3BM-CAM1520 Water License Renewal

Re: Crown-Indigenous Relations and Northern Affairs Canada's comments on the Hamlet of Cambridge Bay's renewal application for water licence #3BM-CAM1520 for municipal undertakings – Hamlet of Cambridge Bay

Technical Review Memorandum

Figure of sampling stations taken from Sewage Lagoon O&M Manual

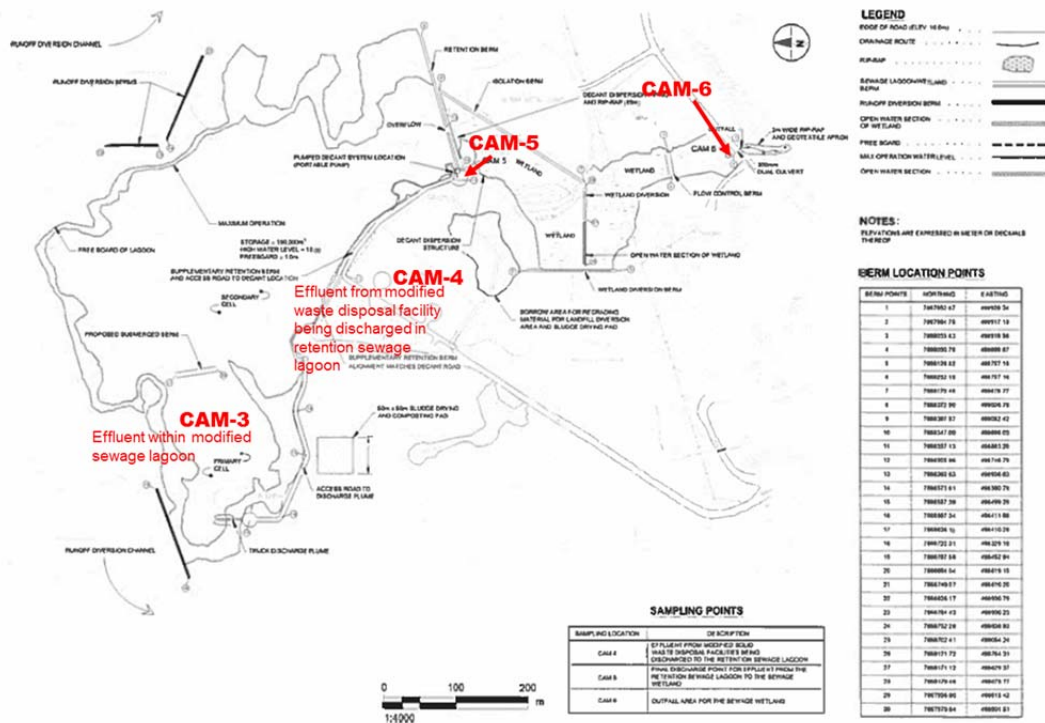
As mentioned above, the sewage and solid waste facilities in Cambridge Bay are co-located, and they share some water management features. Section 6.5 of the Solid Waste Disposal Facility Operations and Maintenance (O&M) Manual: “*surface water collecting in control ponds can be pumped into the lagoon.*” The 2018 annual reports confirms this practise is used: “*Sometime waste run-off required to pump out to sewage lagoon when snow melts or rains flooded the waste facility.*” Additionally, surface water draining from the landfill is directed via a ditch to the wetland that also receives treated sewage from the retention lagoon (personal communication, B.Pedersen, March 13, 2020). These features are illustrated in figure C-14 of appendix D in the Solid Waste O&M Manual and the figure below.

Part D Item 5 of the current water licence requires sampling at station CAM-5 and sets discharge criteria for station CAM-6. These station locations are identified in the figure above. The licensee has provided water quality results for CAM-5 in 2015, 2016, 2017 and 2018, while results for CAM-6 are available for 2015, 2016 and 2018. Four of the six samples at CAM-6 had pH values outside the 6 - 9 range set by the licence, with values ranging from 9.36-10.20. The treatment through the retention cell causes pH to increase; for 3 of 6 samples, pH is within criteria at CAM-3 in the sewage lagoon and above pH 9.0 at CAM-5, when leaving the retention cell for the same dates.

The water licence has no discharge criteria for metals. However, metal concentrations in the effluent of the waste disposal facility at CAM-4 are elevated, as might be expected from contact water at a landfill. Iron concentrations are on average 10 570 µg/L (range 322 - 24 500 µg/L) and though they are reduced in the wetland, concentrations are still high at the final discharge point CAM-6 (average 544 µg/L, range 301 - 739 µg/L). These iron concentrations are above the Guidelines for the discharge of treated municipal wastewater in the Northwest Territories and the Canadian water quality guidelines for the protection of aquatic life (CWQG-PAL) in freshwater – long term, which are both 300 µg/L. Copper is the other metal with concentrations with concentrations at the final discharge point CAM-6 (average 6.0 µg/L, range 3.4 – 12.6 µg/L) regularly above the CWQG-PAL. The guideline for copper is variable depending on water hardness, and for the samples measured it is almost always 4 µg/L. The 2015 CAM-6 samples also have elevated aluminum, cadmium and lead concentrations, but it was a single occurrence, and concentrations at CAM-4 on the same date are not elevated.

CIRNAC recommends the licensee explore options to reduce pH of the retention cell effluent to meet licence discharge criteria. Additionally, CIRNAC recommends the licensee explore options to reduce metal concentrations in landfill contact water.

CIRNAC also recommends discharge criteria be re-considered to include metal concentrations if applicable, since the effluent tested is in part from a landfill.
